Subject: CHIPS AND SCRATCHES ON FRONT SEATBACK COVER - LEATHER SEATS	Bulletin No: 09-034/04
	Last Issued: 11/22/2004

This bulletin supersedes the previous bulletin 09-034/04, issued on 9/7/2004. The PARTS INFORMATION has been revised.

2004 RX-8 with VINs lower than JM1FE****40128213

**LOOK HERE FOR
CHIPS/SCRATCHES**

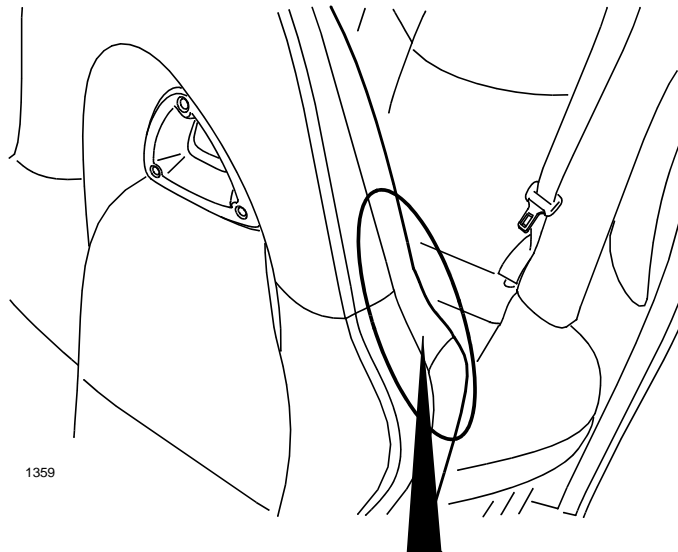
On 2004 RX-8 vehicles with leather seats, some customers may complain of noticeable chips and scratches that appear on the front seatback cover, near the headrest where the seatbelt comes in contact with the seatback cover. These chips and scratches may be caused by the seat belt coming into contact with the seatback when using the seat belt or when the rear door is closed.

2. For vehicles with leather seats built prior to November 12, 2003, replace the front seatback cover and front seat belt assembly with modified ones. See appropriate Workshop Manual section 08 - FRONT SEAT BELT REMOVAL / INSTALLATION for replacement of the seat belt assembly and section 09 - FRONT SEAT DISASSEMBLY / ASSEMBLY for replacement of the seatback cover.
3. For vehicles with leather seats built between November 12, 2003 and December 15, 2003, replace only the front seatback cover with a modified one. See appropriate Workshop Manual Section 09 - FRONT SEAT DISSASSEMBLY / ASSEMBLY for replacement of the seatback cover.
4. Verify repair.
